# SAMBOR PROJECT REPORT

a Further Report for the Information  
of the Advisory Board of the Mekong Committee

Subject: Further Report of Sambor Project

**Part I : Comments on Item 5 - Sambor Project Report, 12 th Meeting of the  
Advisory Board of the Mekong Committee**

### Flood Inflow and Outflow

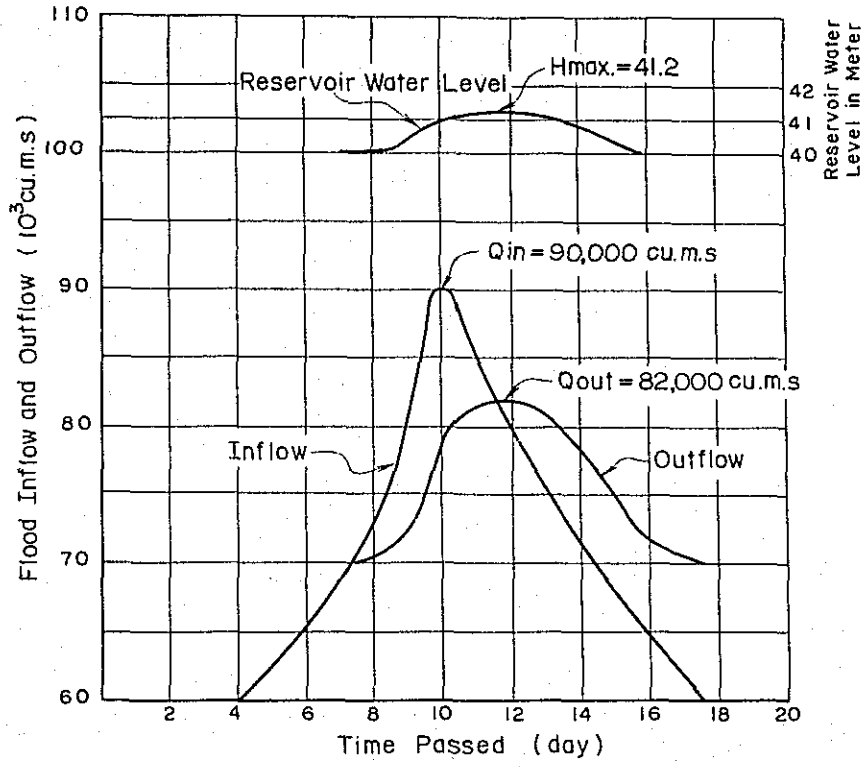
- a) The difference in elevation between the maximum high water level and the crest of dam and earthfill dikes is only 2 meters. Taking into consideration the great length of the reservoir, there is a risk that the combined action of wind, waves and cyclonic depression may cause some water to pass over the dikes, and possibly erode and destroy them, which would release ten billion cubic meters of water, all over the Mekong valley. The Board did not have in hand enough data to calculate what should be a safe free board but noted that, in the case of Nam Mong, an earthfill dam annexed to Pa Mong with much smaller fetch, the difference between high water level and crest elevation is three meters, which suggested that the difference should be increased at Sambor due to larger size of reservoir.

More detailed calculations have been undertaken using a hydrograph which has a peak discharge of 90,000 cu.ms., taking into consideration surcharge effect as shown on the attached figure. This flood hydrograph is estimated on the basis of the 1966 flood (recorded maximum flood).

According to our calculations, the maximum water surface elevation will rise to 41.2m. On the other hand, the wave height is 2.0m to 2.5m assuming the wind velocity of 20m per second for 10 minutes and the fetch of 30 to 50 km. Adding this value to the maximum water surface elevation, the ultimate water surface elevation becomes 43.2m to 43.7m which is below the dam crest elevation 44.0m. Furthermore, the maximum flood discharge of 90,000 cu.ms is considered to be a flood of a frequency of once in 10,000 years, and it will be possible to draw down the reservoir level in advance by establishing good communication system with the upstream gauging stations. From these considerations above, the dam crest elevation of 44.0m is considered appropriate.
